# Access Compliance Report

## Public Rights-of-Way

Intersection ID: 53631	Main Street: PROVIDENCE_RD_WEST	Cross Street: BEACON_VALLEY_ST	Location: SE
ADA ID: 2465B2DB702E	Ramp Type: Perp	Initial Pass/Fail: Fail	Overall Compliance: No
Codes/Mitigation Info/Possible Solution		Field Measurements/Component Compliance	
Severity Score: 8.75

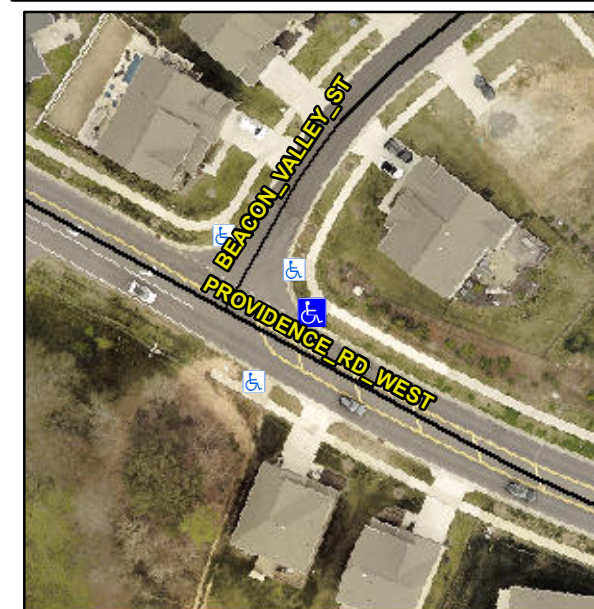
**R304.5.1**

**Remove & Replace Entire Ramp.**
